# UNITED STATES PATENT AND TRADEMARK OFFICE

APPLICATION NO.	FILING DATE	FIRST NAMED INVENTOR	ATTORNEY DOCKET NO.	CONFIRMATION NO.
10/798,020	03/11/2004	Otto Schempp	2133.028USU	5894

<b>Office Action Summary</b>	<b>Application No.</b>		<b>Applicant(s)</b>	
	10/798,020		SCHEMPP, OTTO	
	<b>Examiner</b>		<b>Art Unit</b>	
	Thanh-Tam T. Le		2839

## DETAILED ACTION

**FIGURE A**

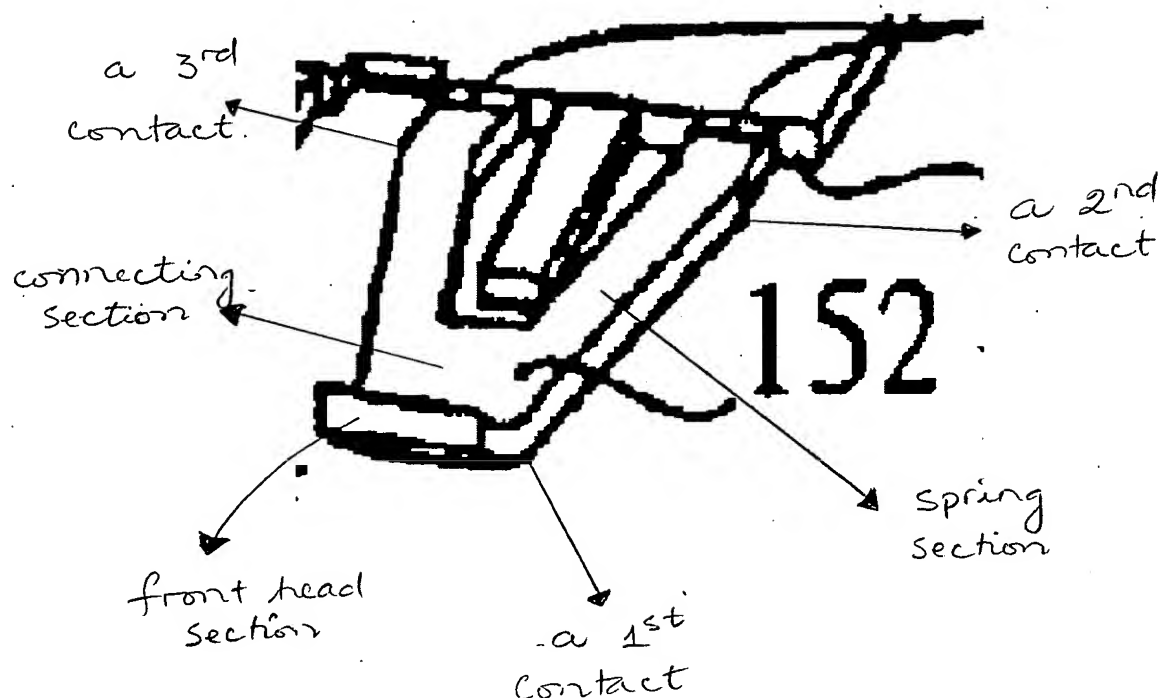
- a plurality of signal terminals (88) that are arranged in the housing (since the terminals 88 are connected to signal terminals 54 of the header contacts 24 (column 10, lines 5-9); therefore, 88 are the signal terminals); and
- at least one ground terminal (84, figure 4) with at least a first contact section (152) and a first spring arm section (not labeled), with the first contact section having at least one first and second contact (a FIGURE A below), wherein the first and second contacts are mechanically coupled.

Regarding claim 38, the first contact section comprising a third contact (the FIGURE A below)

Regarding claim 40, a front head section (the FIGURE A below) on which the first and second legs are connected to one another, and the first contact is arranged on the head section, the second contact is arranged on the first leg, and the third contact is arranged on the second leg.

Regarding claim 42, the first spring arm section having a connecting section (the FIGURE A below) and a spring section (the FIGURE A below), wherein the spring section being inclined with respect to the connecting section.
